*Errata***1**

Manual: 27784

Manual Index: 01

Figure 2-2: Pin Layout of the Digital Input and Output Interface Connector CON2

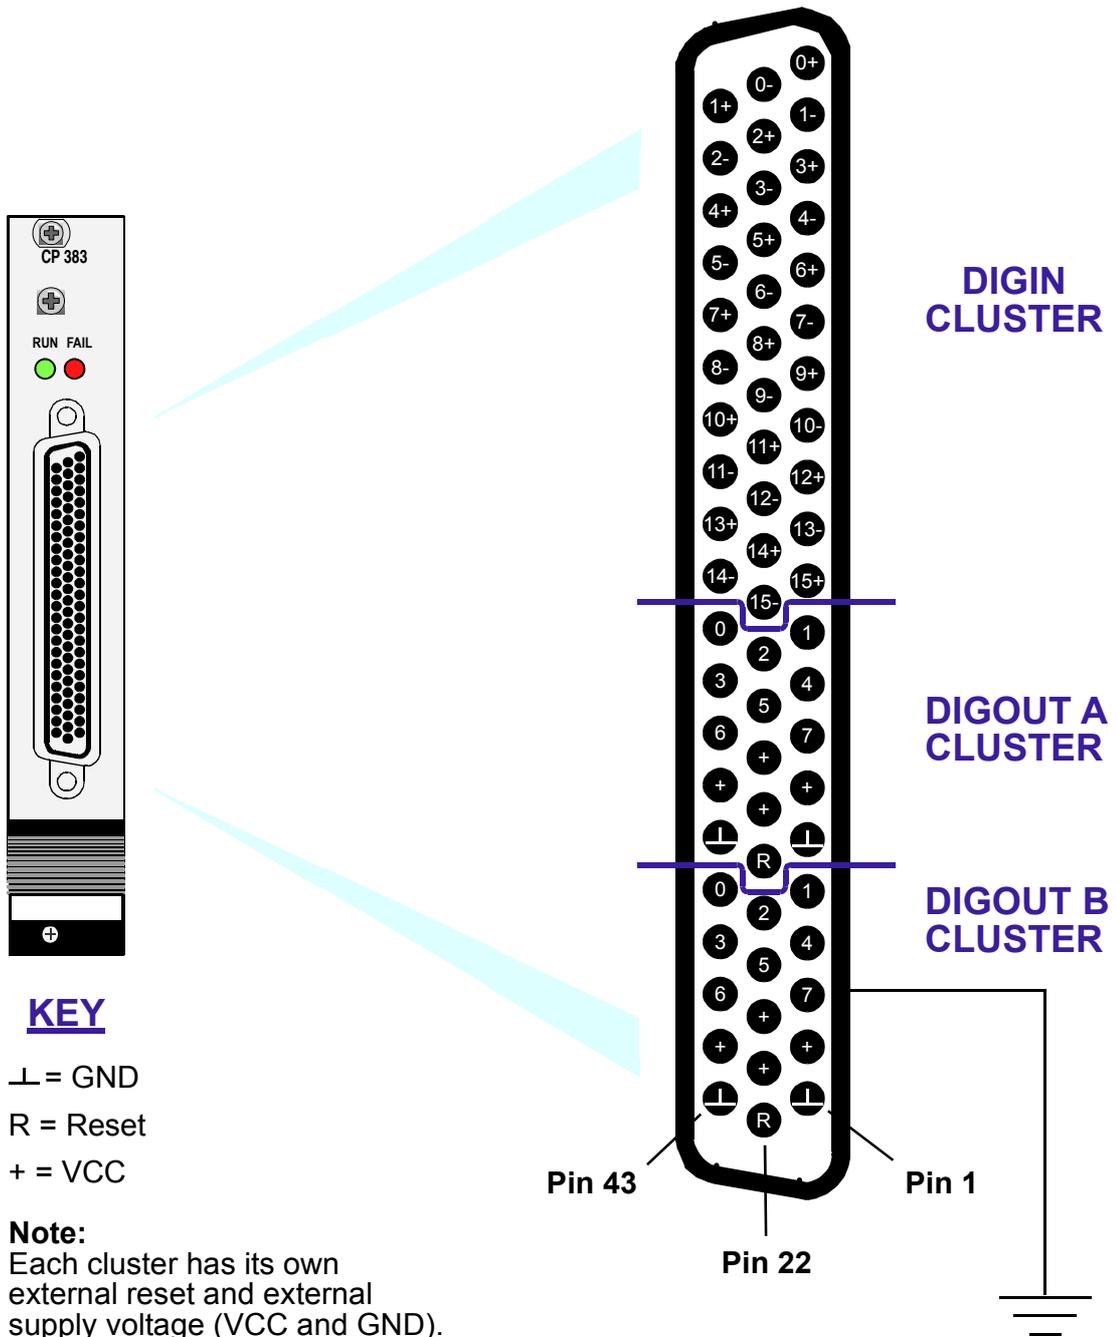
1. Reference: Page 2 - 6, Chapter 2.7.1, Figure 2-2

The referenced information (figure) is superseded by the following replacement figure. The replacement figure revises pins 44 and 49.
